6.1 **67-69 BUCKHURST STREET, SOUTH MELBOURNE**

PREPARED BY: **PATRICIA STEWART, FISHERMANS BEND URBAN RENEWAL SENIOR PLANNER**

1.1 To provide a Council position on a planning permit application to the Minister for Planning C/- Department of Environment Land, Water and Planning (the Department) for Planning Permit Application Number PA2101152, 67-69 Buckhurst Street, South Melbourne.

Figure 6: Roof top Services.

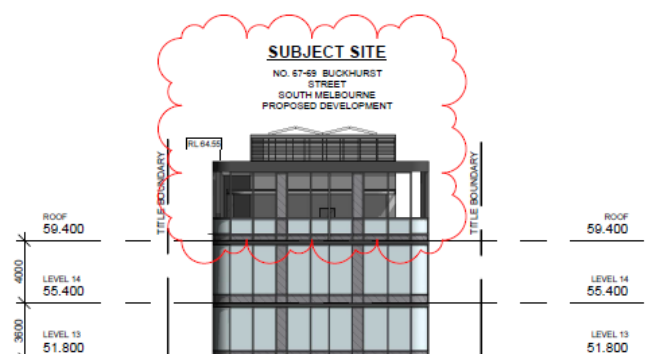
Views to the roof top services are to be concealed by continuation of the framing elements of the tower façade beyond the parapet. The success of the additional massing contributed by this element is questionable. The design response would not fully obscure views of the plant equipment. It is considered the extent of facilities on this level could be rationalised by the removal of storage areas, WC facilities and the reconfiguration of services centrally to the site along with the deletion of the covered structure to reduce the dominance of services at this level.

Figure 7: Proposed waste allocation streams

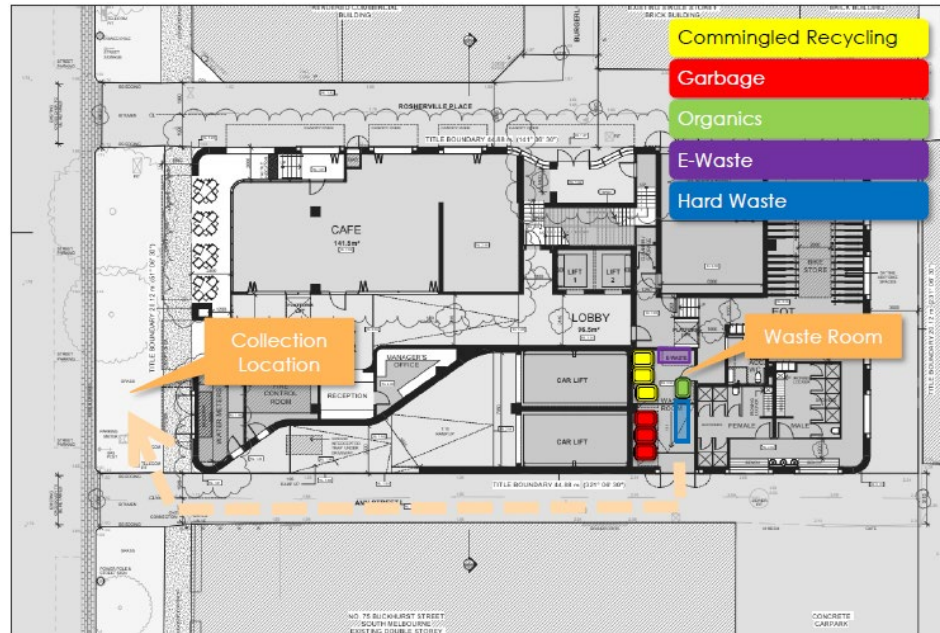
- WMP has 3x1100L waste bins and 3x1100L recycling bins (collected twice a week) but floor plans only detail 2x1100L bins for both streams.
- Require more information about bin collection time to ensure compliance with Council’s Local Laws requirements.
- Would highly recommend installing dual chute system.

Figure 8: Proposed waste collection –green area denotes waste collection / loading area.

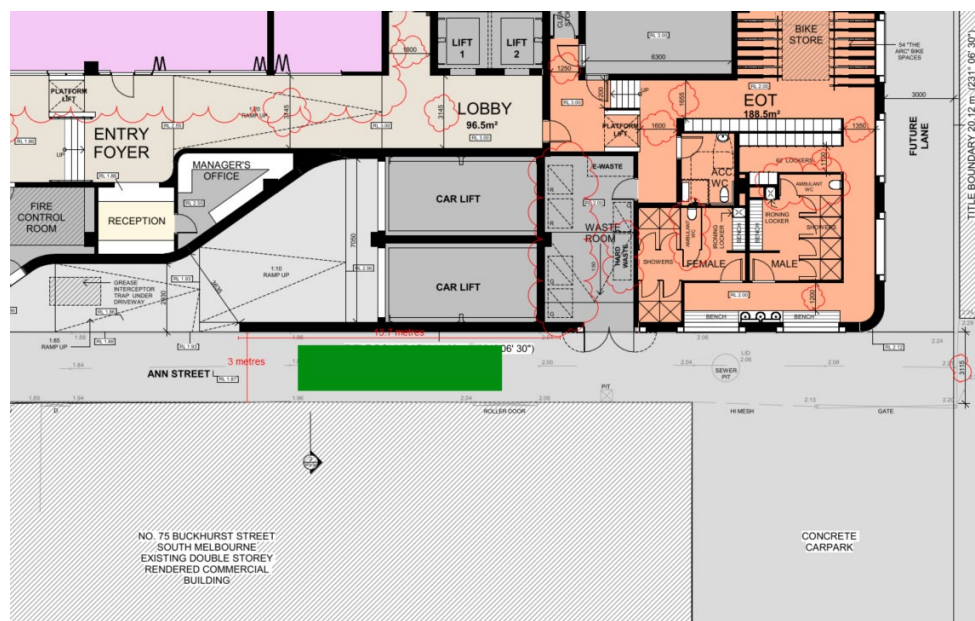
It is recommended that any waste collection services occur between 10am and 2pm, being outside of peak traffic times within the area. Council's Waste Manager Officer advises the proposed number of collections per week is acceptable. Reducing the number of vehicular traffic movements on site would assist to minimise conflict with cars entering and existing as discussed at section 11.5.3 of this report.
